UNITED STATES PATENT AND TRADEMARK OFFICE

Office Action Summary	Application No. 6 10/084,580	Applicant(s) TRIPATHI ET AL.	
	Examiner Freshteh N. Aghdam	Art Unit 2631

DETAILED ACTION

Figure 2

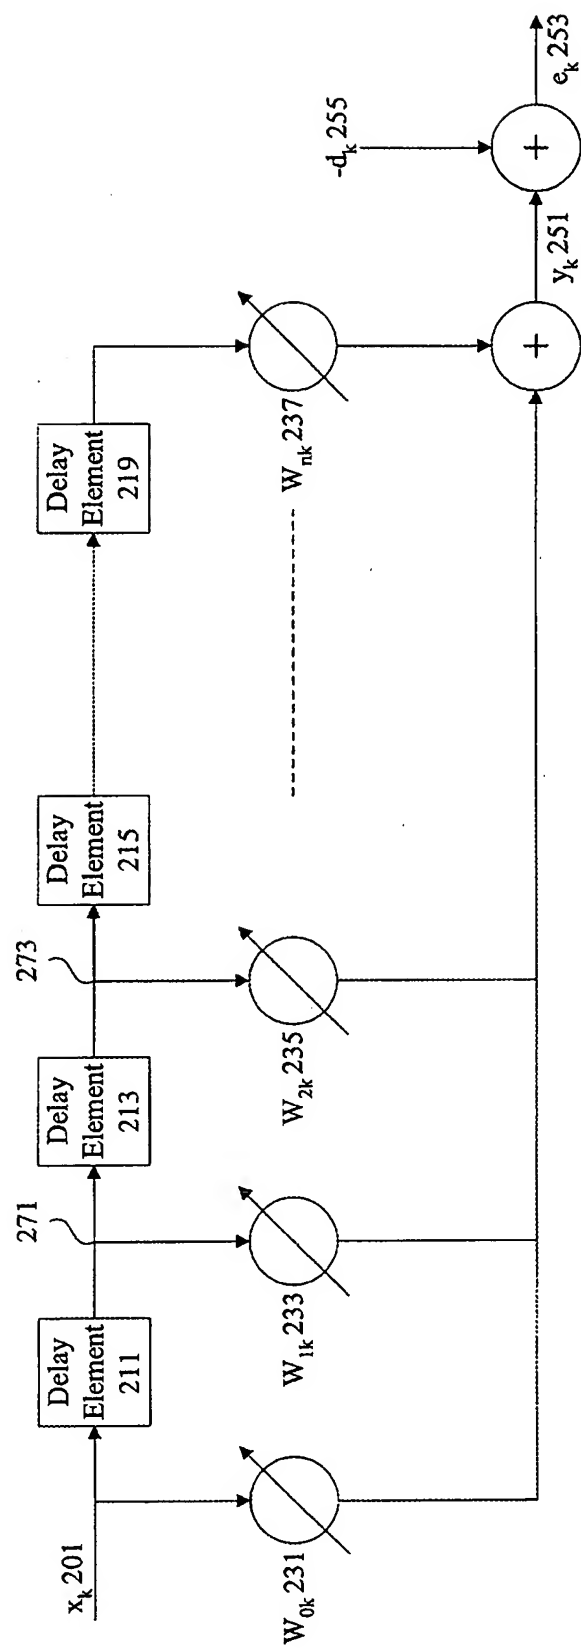
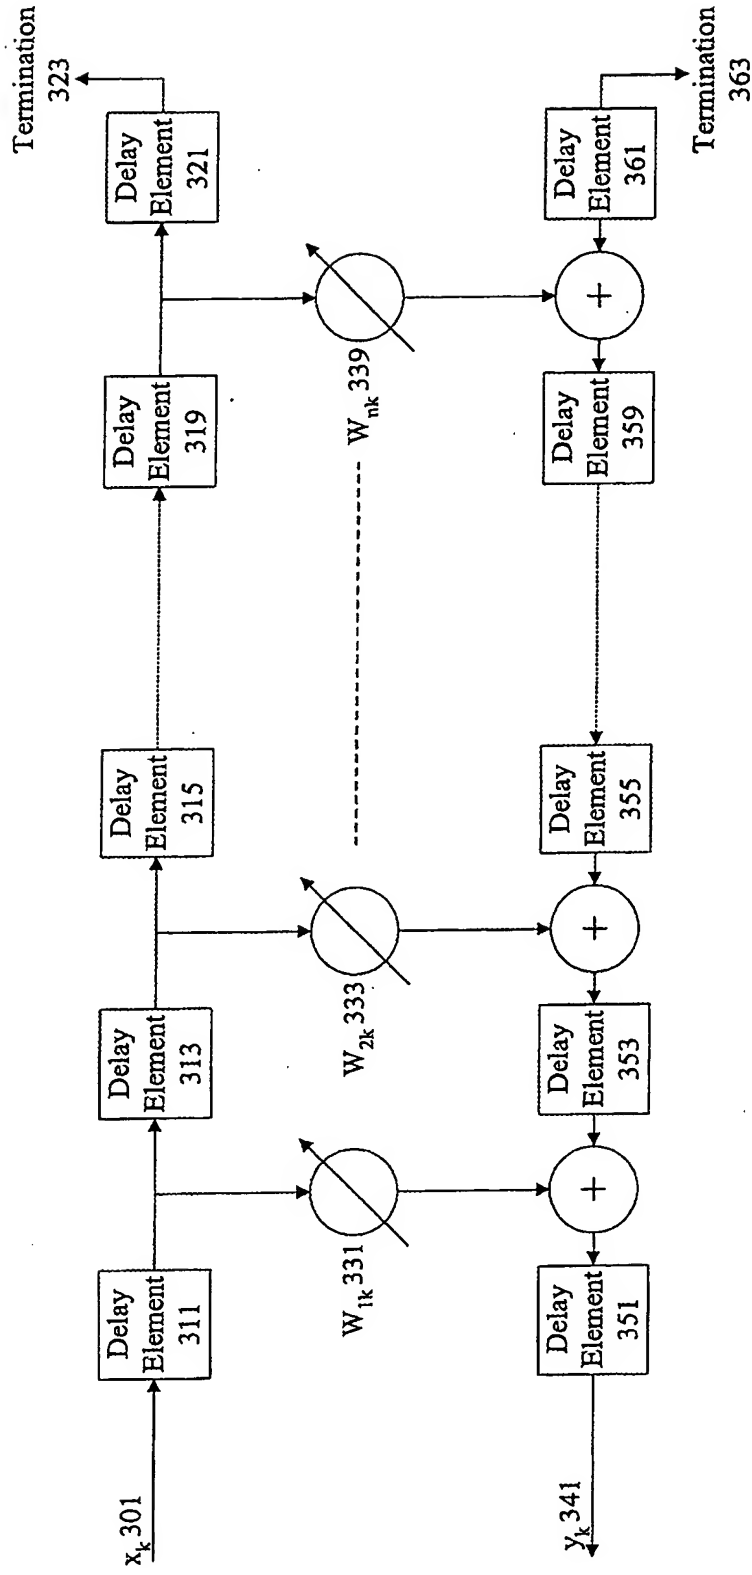
The drawings are objected to under 37 CFR 1.83(a) because they fail to show that figures 2 and 3 are prior art as described in the specification. Any structural detail that is essential for a proper understanding of the disclosed invention should be shown in the drawing. MPEP § 608.02(d). Corrected drawing sheets in compliance with 37 CFR 1.121(d) are required in reply to the Office action to avoid abandonment of the application. Any amended replacement-drawing sheet should include all of the figures appearing on the immediate prior version of the sheet, even if only one figure is being amended. The figure or figure number of an amended drawing should not be labeled as "amended." If a drawing figure is to be canceled, the appropriate figure must be removed from the replacement sheet, and where necessary, the remaining figures must be renumbered and appropriate changes made to the brief description of the several views of the drawings for consistency. Additional replacement sheets may be necessary to show the renumbering of the remaining figures. Each drawing sheet submitted after the filing date of an application must be labeled in the top margin as either "Replacement Sheet" or "New Sheet" pursuant to 37 CFR 1.121(d). If the examiner does not accept the changes, the applicant will be notified and informed of any required corrective action in the next Office action. The objection to the drawings will not be held in abeyance.

As to figures 2 and 3, the expression "prior art" is not recited to distinguish the drawings of the present invention from the existing devices.

Figure 3

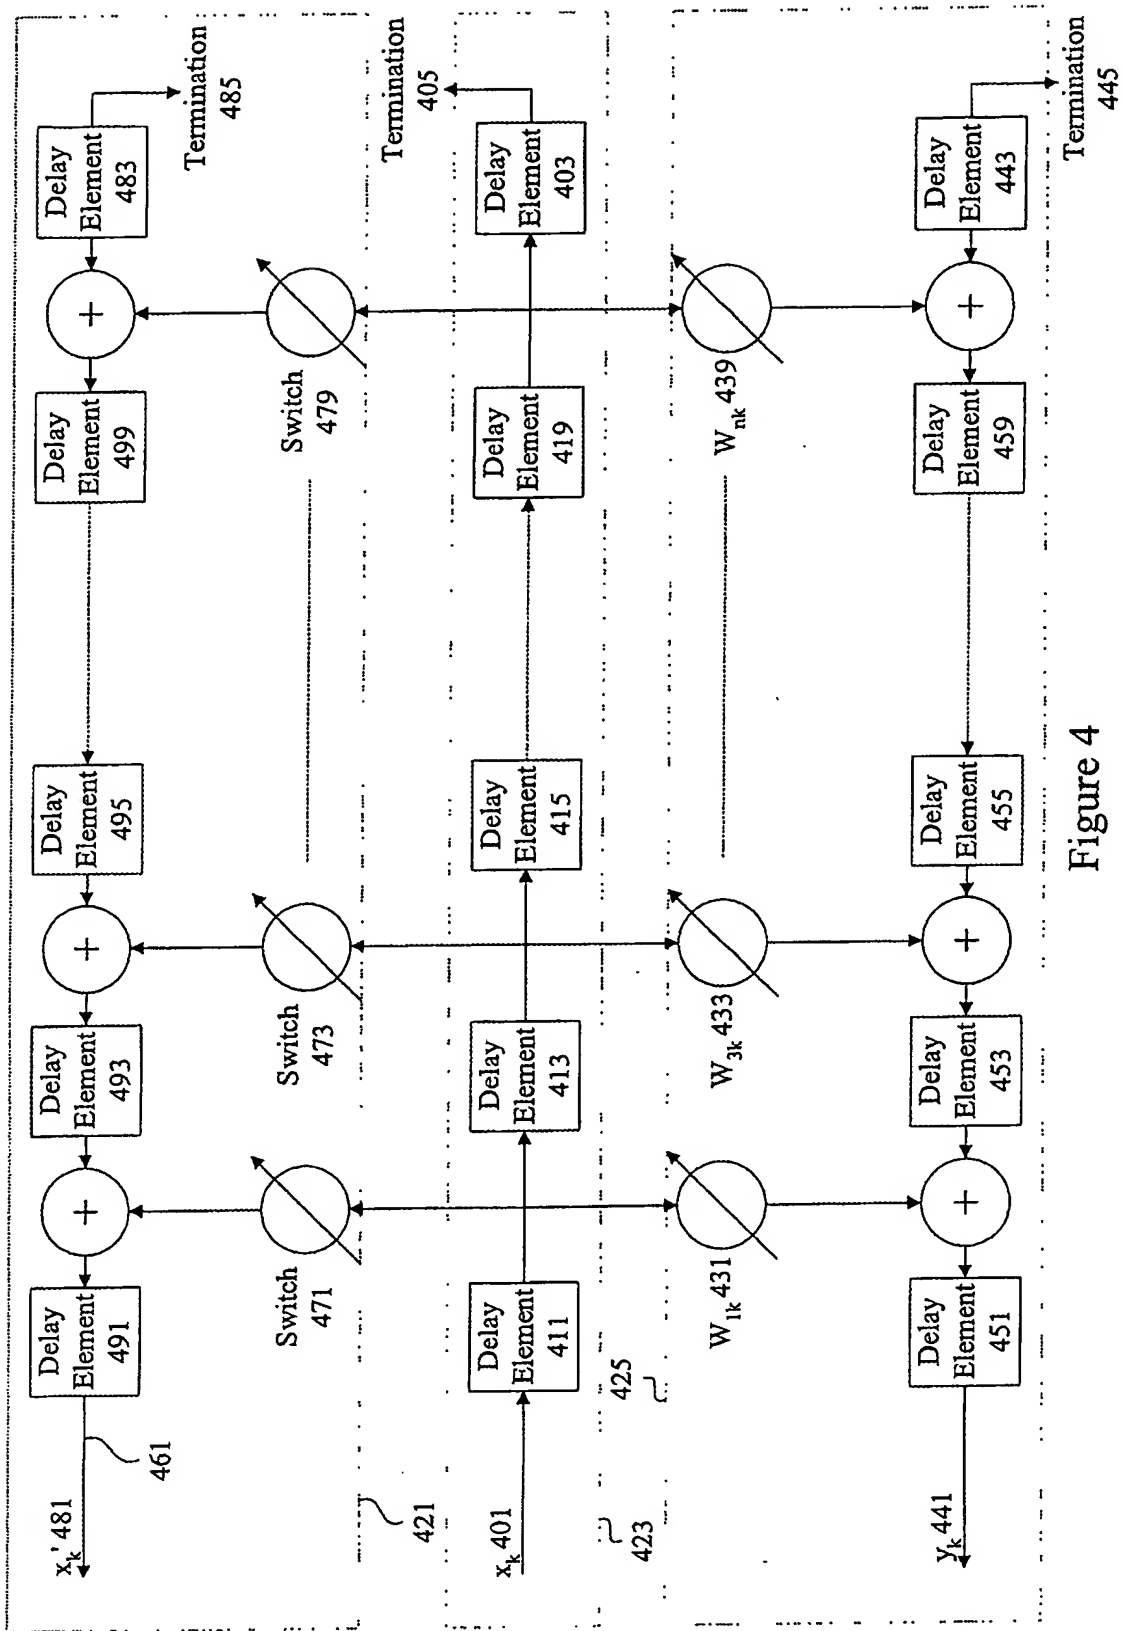
As to claims 1, 3, and 5, the admitted prior art teaches an adaptive equalizer comprising an input delay line including delay elements (Fig. 3, means 311-321), the input delay line is configured to receive an input signal (301) and provide intermediate signals, wherein intermediate signals are shifted representations of the input signal (i.e. time or phase shifting as recited in the specification see page 8, lines 27 and 28); a
